City of St. Charles, Illinois

Ordinance No. 2016-M-10

An Ordinance Amending Chapter 15.04 "Building Code", Section 15.04.020 "One-Family and Two-Family Residences-Regulations Adopted and Modified" of the St. Charles Municipal Code

Figure R403.1 (1)
Concrete and Masonry Foundation Details

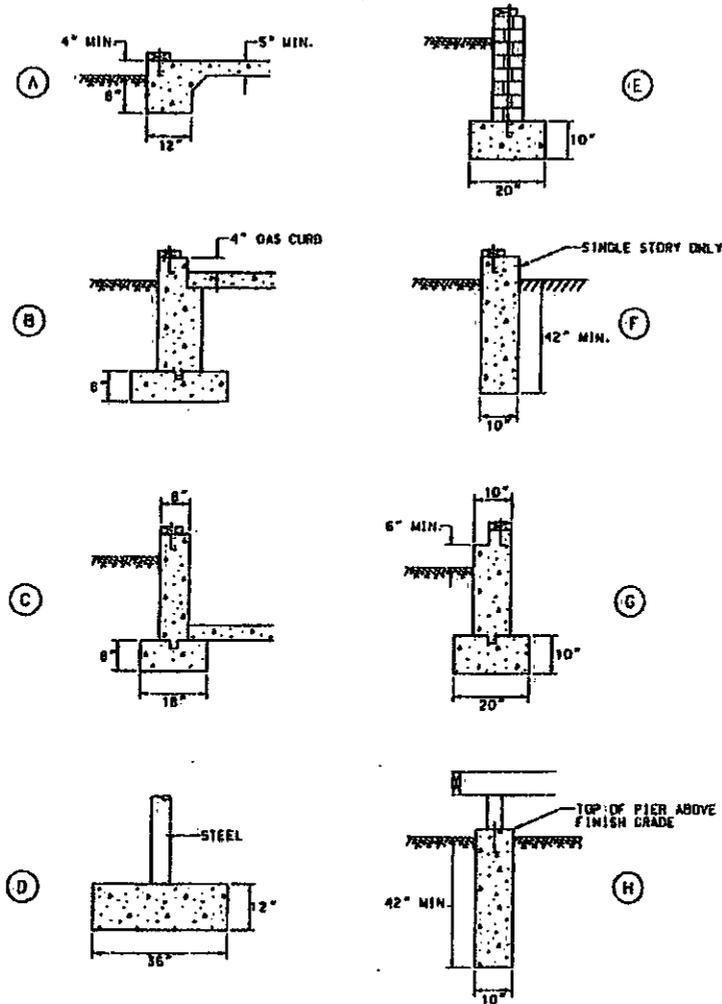
F. Figure R403.1 (1) Concrete and masonry foundation details: Delete this figure and substitute the following therefore:

- A= Typical turned down garage slab.
- B= Typical foundation detail for attached garage with gas curb.
- C= Typical footing and wall detail.
- D= Typical pier pad for lolly column in basement.
- E= Typical footing and wall detail for masonry block wall.
- F= Typical trench foundation.
- G= Typical wall and footing for brick veneer home.
- H= Typical posthole detail for deck.
